10245 Capitol View - PRELIM  
Capitol View Park Historic Dist

Re: Montgomery County  
Macon Construction  
MD 192 (Capital View Avenue)  
Review of Sight Distance  
Evaluation for Option #2

MEMORANDUM

FROM: Michele Oaks, Senior Planner  
Historic Preservation Section

1  
Front Elevation  
1/4" = 1'-0"

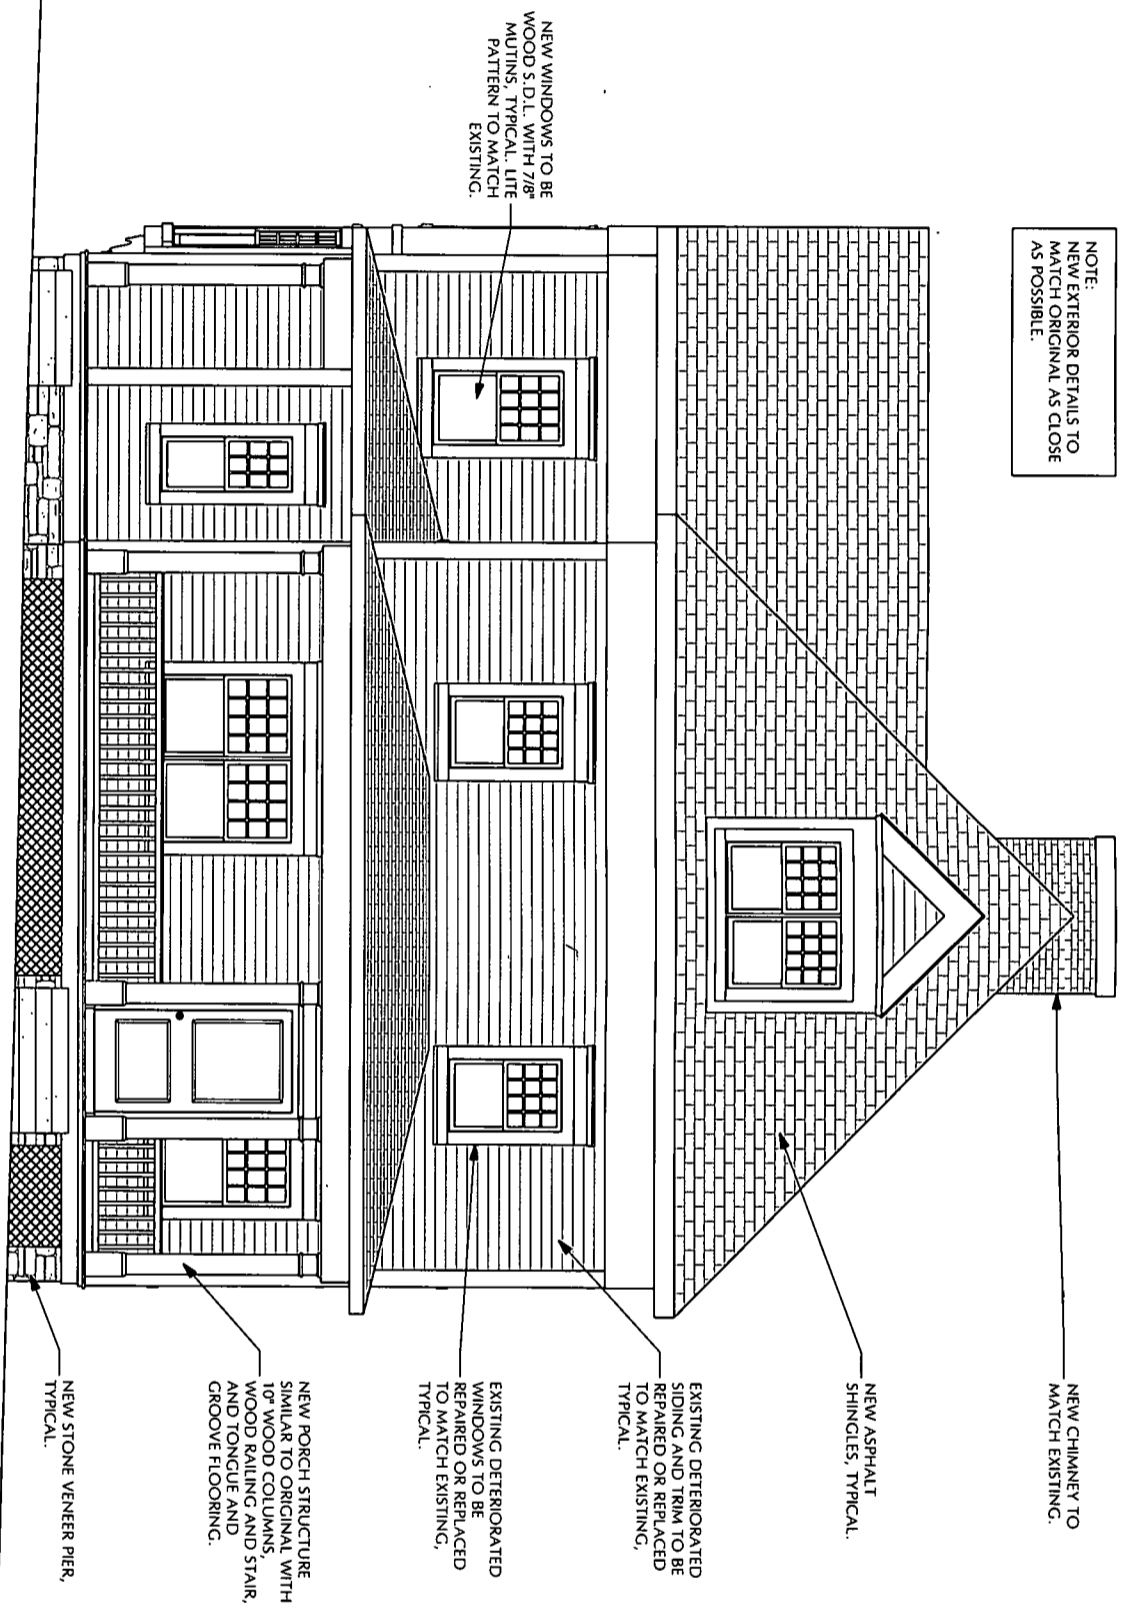
The front porch was original to the house and is a key feature of Foursquares, so we are pleased to see this restoration. (Topic #4) The roof line was incorrectly drawn on the elevations, however, a point which could impact other design features. The pyramidal roof plan, pitch, and details are an important character-defining feature of this house and should be correctly rendered and preserved.

1 Right Side Elevation  
1/4" = 1'-0"

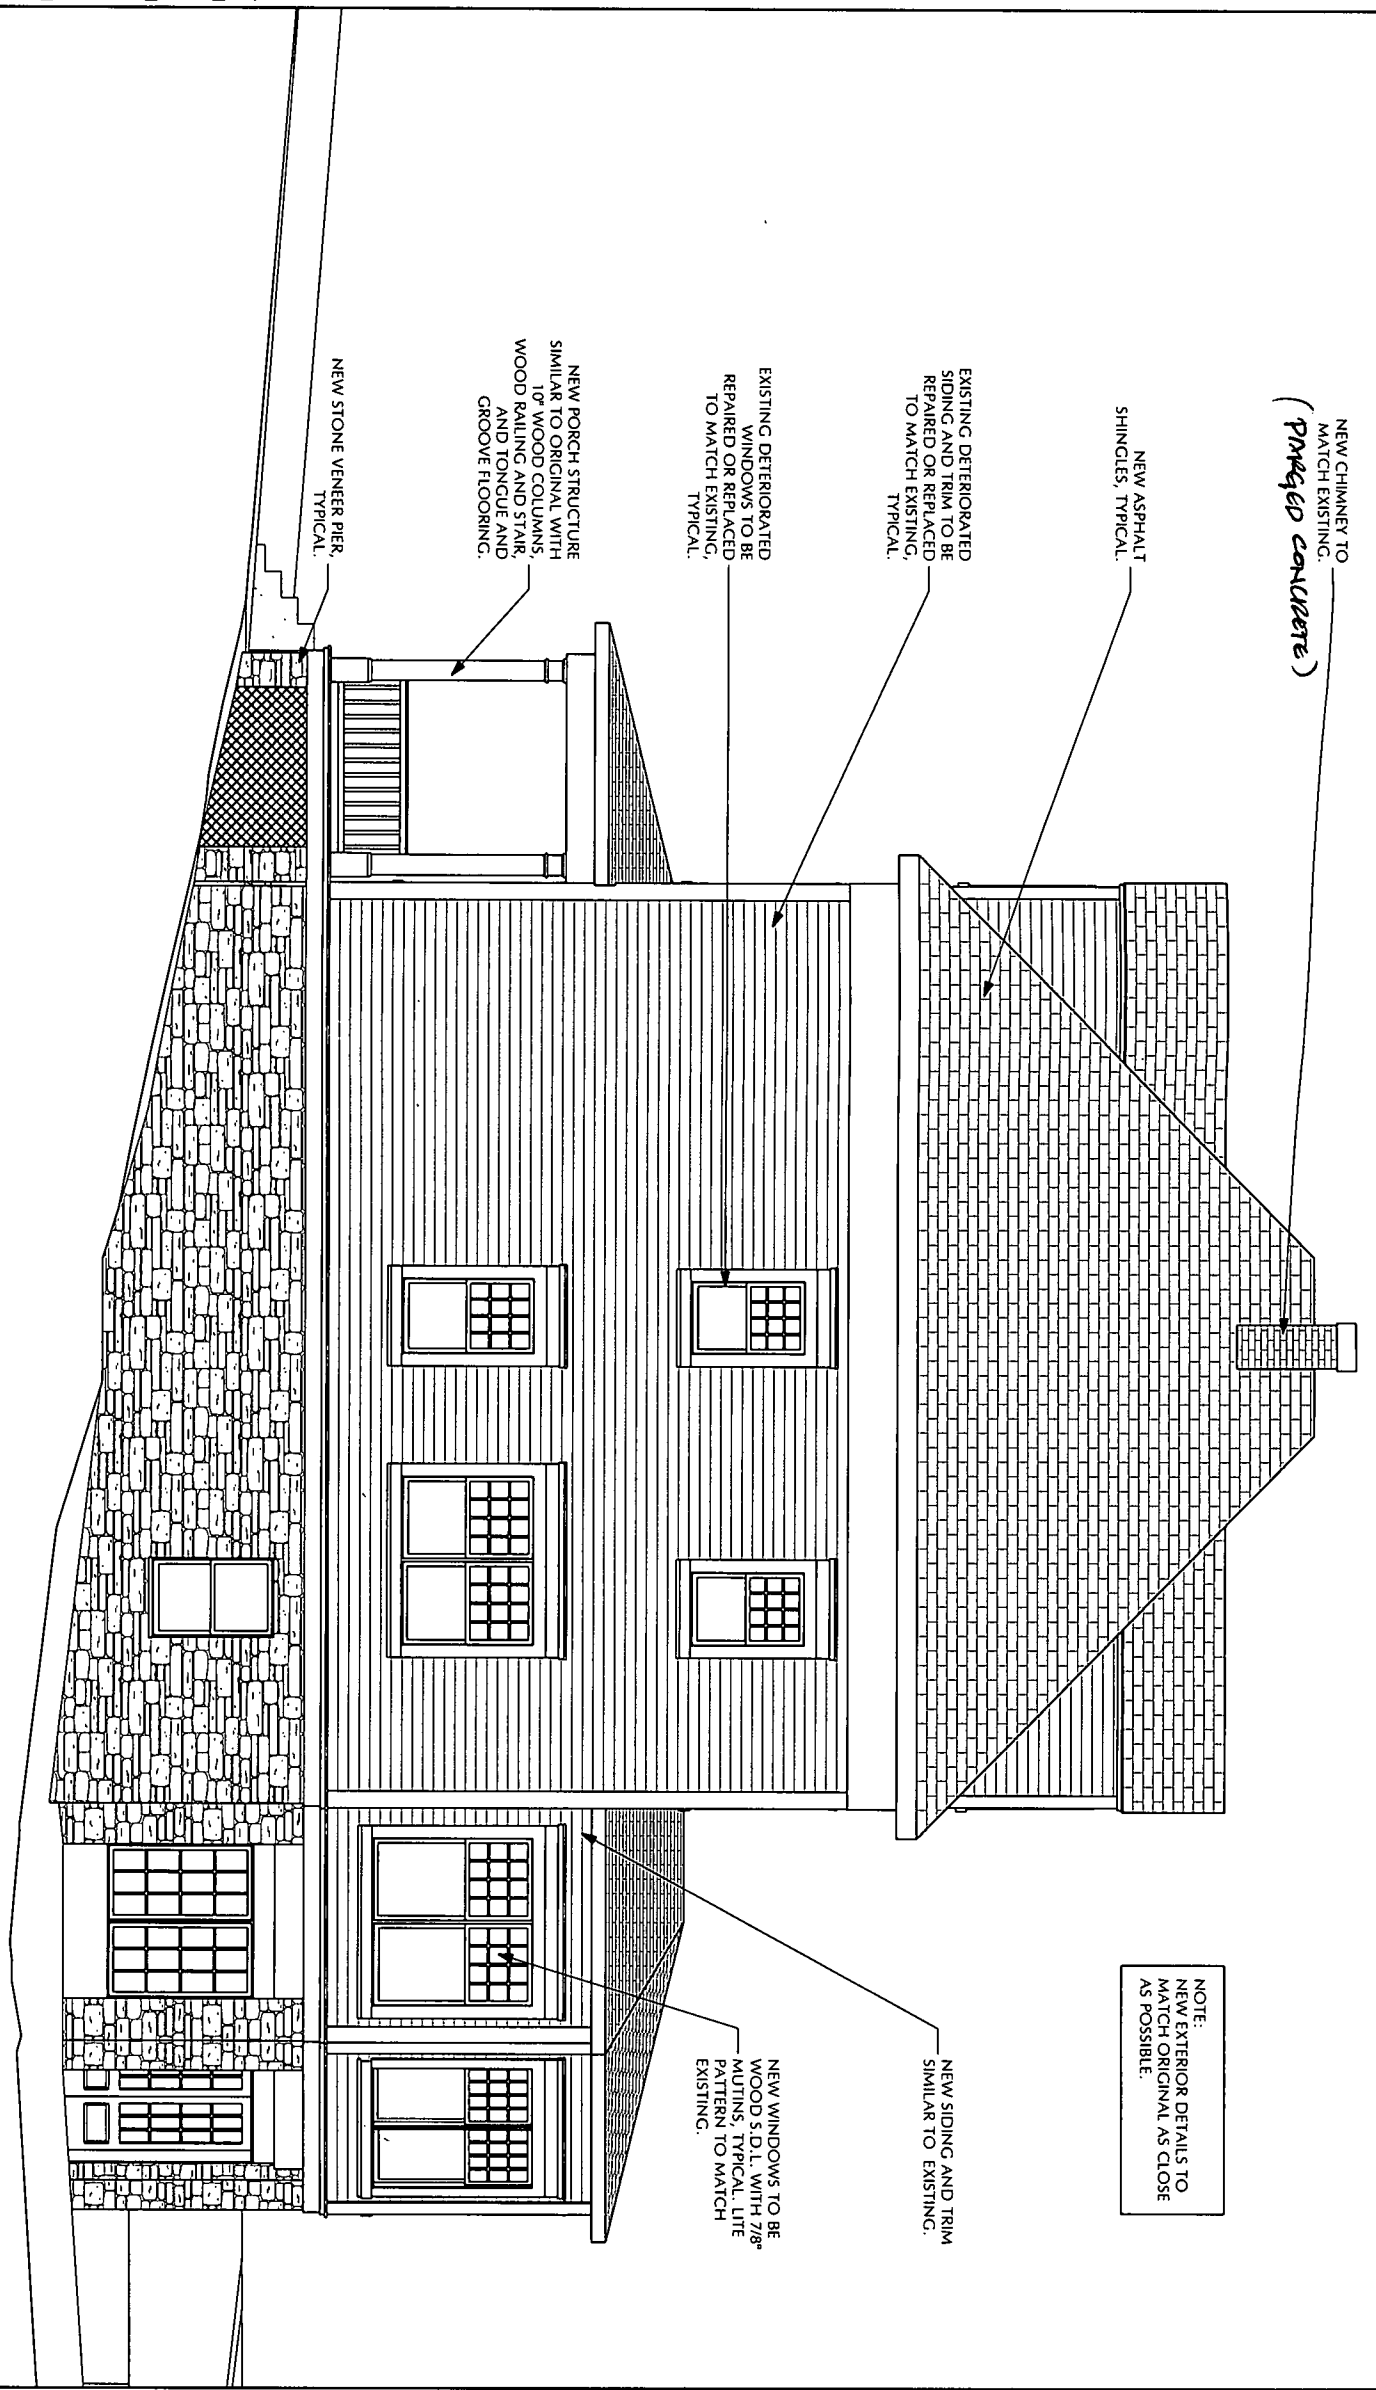
After additional research, staff does believe that the side extension is original to the house. The side addition is shown on the 1941 Klinge' map and the 1927 Sanborn map of Capitol View Park. Typically, staff does not support modifications to original features on side elevations of outstanding resources within the Capitol View Park Historic District. However, given the fact that the Planning Board has approved a subdivision for this lot creating two additional lots to the west - the south (front) and east (left) elevations will become the prominent facades on this house. Therefore, staff would not want to see an addition extend from the left elevation to preserve the right extension, as suggested by a Commissioner at the Preliminary Consultation. The a-symmetrical footprint is an important architectural detail. Although staff would still like to see no modifications to either side elevation, expanding the existing side addition on a façade that will not be very visible once the new houses are erected, seems to be a more appropriate modification to this house. The proposal for this addition is much more sympathetic than the previous HAWP, as its design is in keeping with the existing architectural detailing and is only two-stories in height. Staff is still concerned with the boxed bay detail that is shown on the west façade. The boxed bay will be visible from the front façade. This design element has a mass, which is visible from the front façade. This mass adds another element to this façade and visually draws the eye more towards the side addition and away from the more simplified original block of the house. Eliminating the boxed bay and installing flush paired or triple windows would visually simplify this side addition and bring the focal point back to the main block.

As designed, the plans appear to too greatly compromise the Foursquare style of the house. There is a twin, mirror image house at 10109 Grant Avenue with an extension identical to what we see on the Dwyer House, demonstrating that it was an original design detail. (Topic #6). The removal and enlargement of this side extension so that it rises almost to the roof line is of special concern. Any reconstruction of this extension should continue to appear clearly subordinate to the main, original block of the house.

1. The design of the side addition is modified by eliminating the boxed bay and installing flush paired or triple windows.
